FORM APPROVED
OMB NO. 1004-0137
Expires: January 31, 2018**SUNDRY NOTICES AND REPORTS ON WELLS**
*Do not use this form for proposals to drill or to re-enter an abandoned well. Use form 3160-3 (APD) for such proposals.*5. Lease Serial No.
NMNM112941

COBBER 21-33 FED COM 5H

Devon Energy Production Co., L.P. respectfully requests the following changes to the approved APD:

☐ AMENDED REPORT**WELL LOCATION AND ACREAGE DEDICATION PLAT**

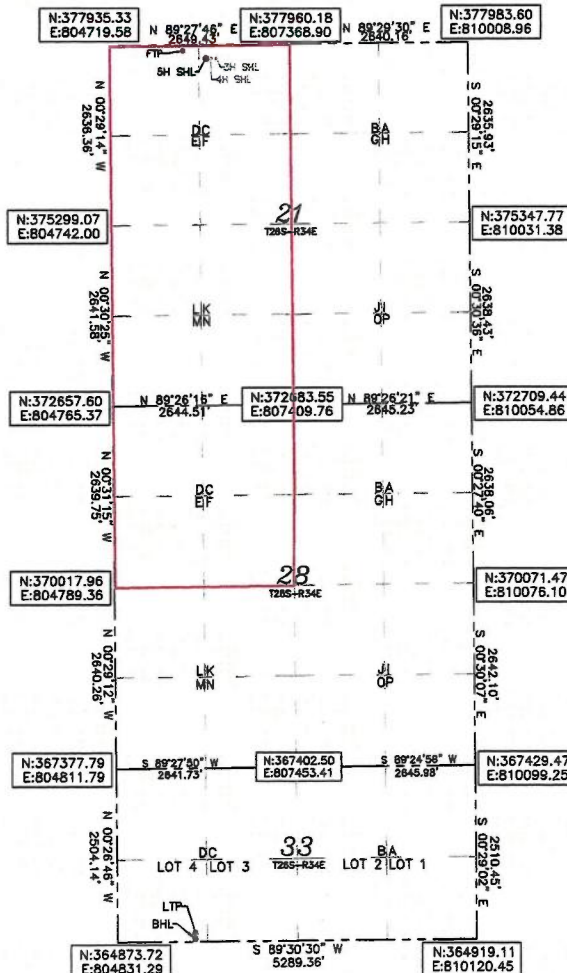
BHL change from 2619 FNL & 1330 FWL, 28-26S-34E to 20 FSL & 1010 FWL 33-26S-34E.

TVD/MD change from 12,975'/20,582' to 12,8635'/25,630'

Name change from Cobber 21-28 Fed 5H to Cobber 21-33 Fed Com 5H.

Please see attached revised C-102, drilling & directional plan.
